Reply on RC1

Author comment on "All models are wrong, but are they useful? Assessing reliability across multiple sites to build trust in urban drainage modelling" by Agneth Nedergaard Pedersen et al., EGU sphere, <https://doi.org/10.5194/egusphere-2022-615-AC1>, 2022

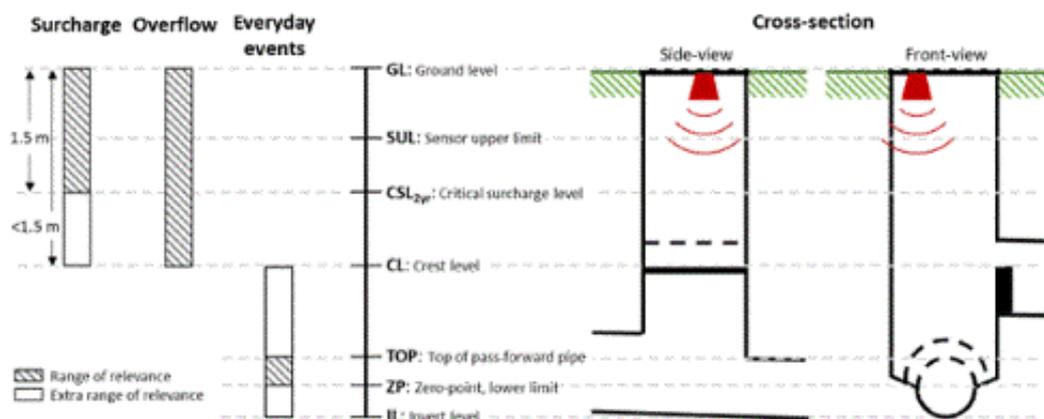
A.2. Figure 2. This is a cross-section, I assume. Include labels to indicate ground level, pipe borders, circle dashed lines, etc.

Thank you for your comments, we will update this figure in the revised manuscript to the version presented below (and update the figure caption accordingly):
